SUBJECT: Forwards inservice insp relief Requests 6 & 7 originally transmitted 790918 & clarified w/addl info, in response to NRC 820316 & 0614 requests.

Re: Turkey Point Units 3 & 4
Docket No. 50-250 & 50-251
Inservice Inspection Relief Request

RELIEF REQUEST NO. 6/7

FIGURE I.

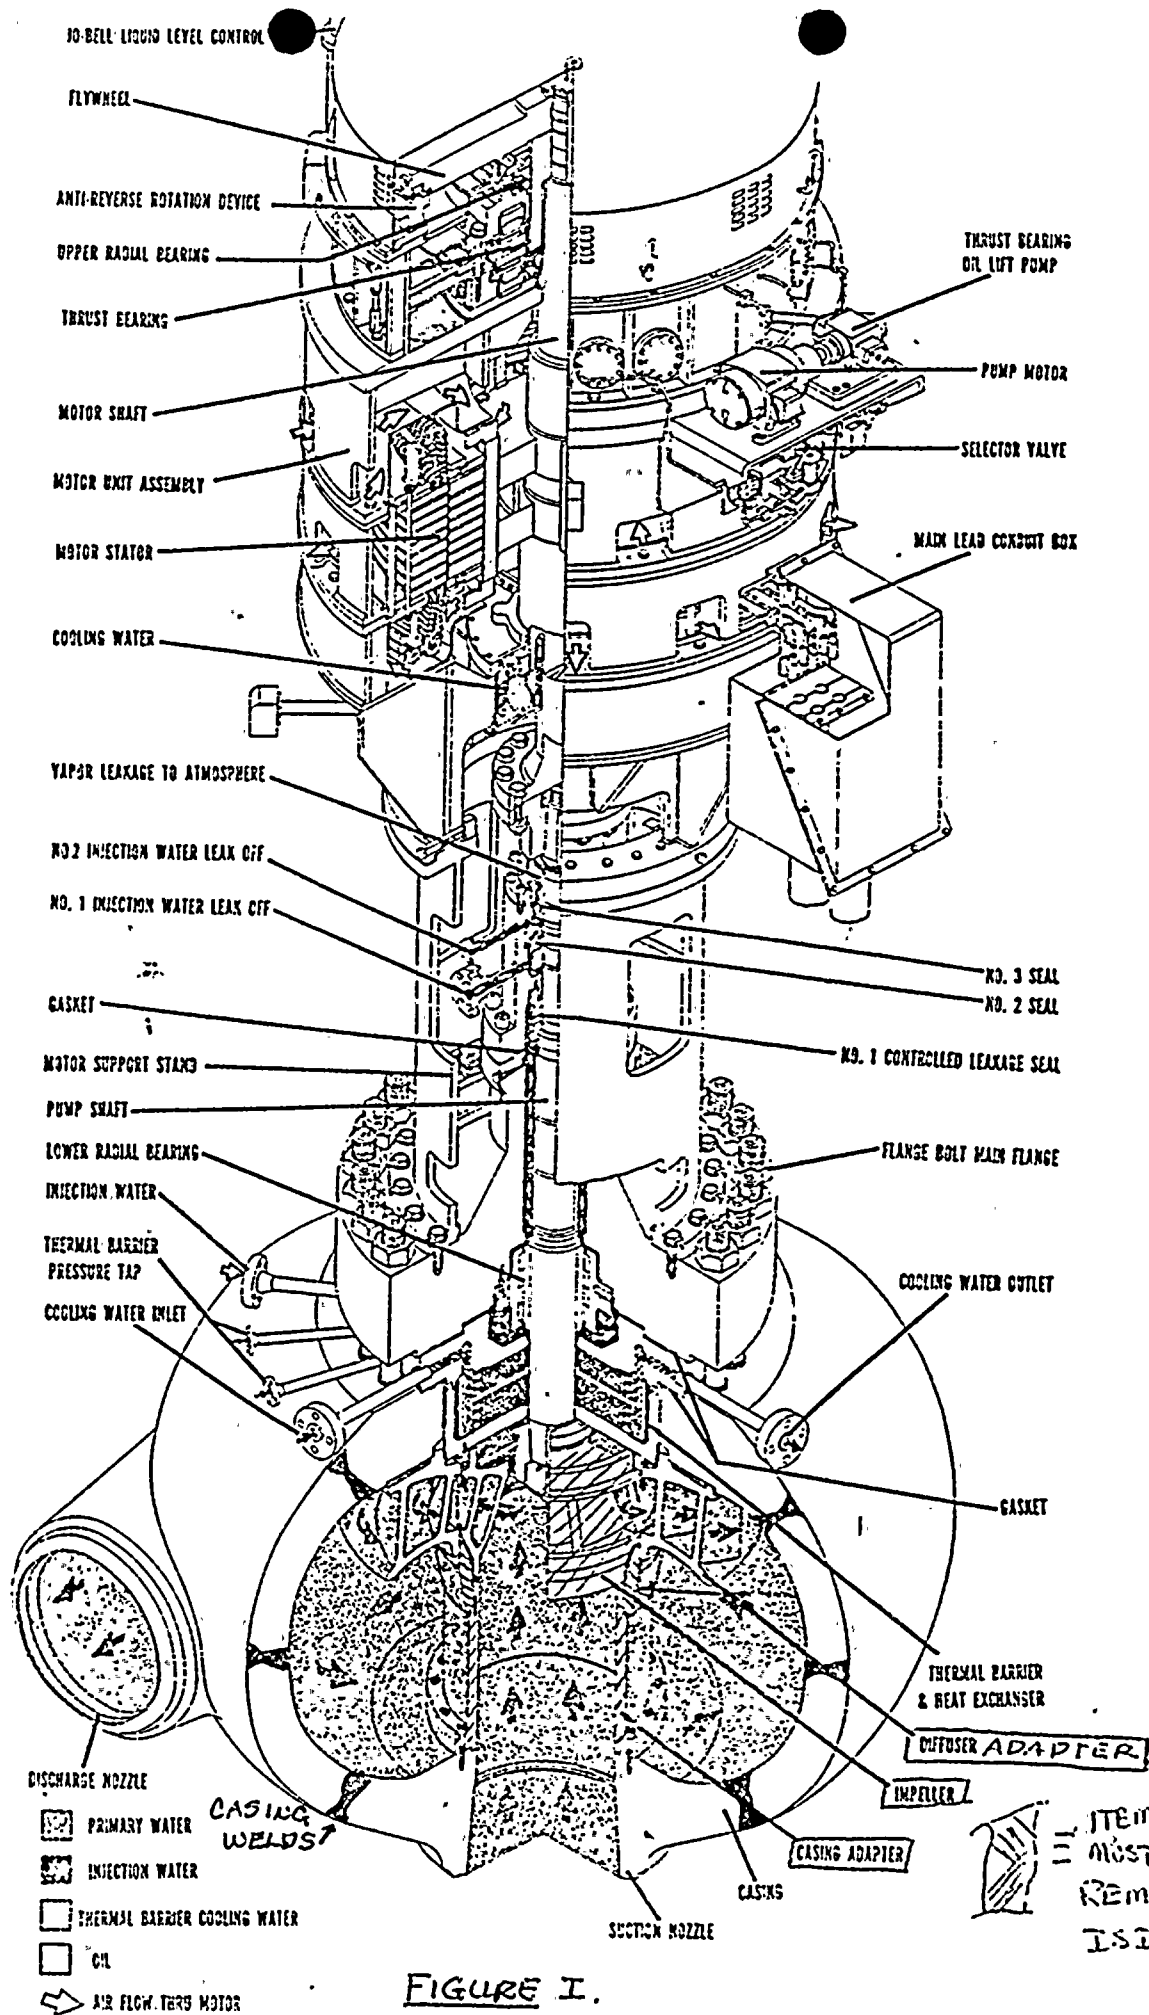
- 2) Radiographic examination is not possible without the complete disassembly of the pump (see figure I). To perform this examination, large expenditures of manhours and man-rem are required with essentially no compensating increase in plant safety. Based on actual data compiled from the radiographic examination of the Turkey Point Unit No. 3 reactor coolant pump casing welds and visual examination of the internal pressure boundary surfaces on one pump, in excess of 5900 man-hours and 46 man-rem exposure was expended in the disassembly, examinations and reassembly of the pump. These examinations are conducted under somewhat adverse conditions which have far reaching effects as depicted in Figure 2 thru Figure 5.

- 3) There is a very low probability, based upon industry experience, to disassembly pump(s) for maintenance purposes. There is no requirement by the pump manufacture (Westinghouse) to disassemble the pump(s) as part of normal maintenance or inspection. Accordingly, Florida Power & Light Company's procedures do not require disassembly of the pump(s) for maintenance or inspection purposes. There are no reported failures within the pump casings with these model pump(s). It's note worthy to mention that removal of the pump impeller does not provide access to the casing internal surfaces which would still prohibit the inspection (visual and volumetric) of the pump to Code requirements. See Figure I for items to be removed for Code ISI examination compliance.

- 1) 100% visual examination of the external surfaces only of one pump casing welds to the extent and frequency of Examination Category B-L-2.
- 2) Partial surface examination of the external casing weld (s) of only one pump, conditions permitting - to the frequency of Examination Category B-L-2.
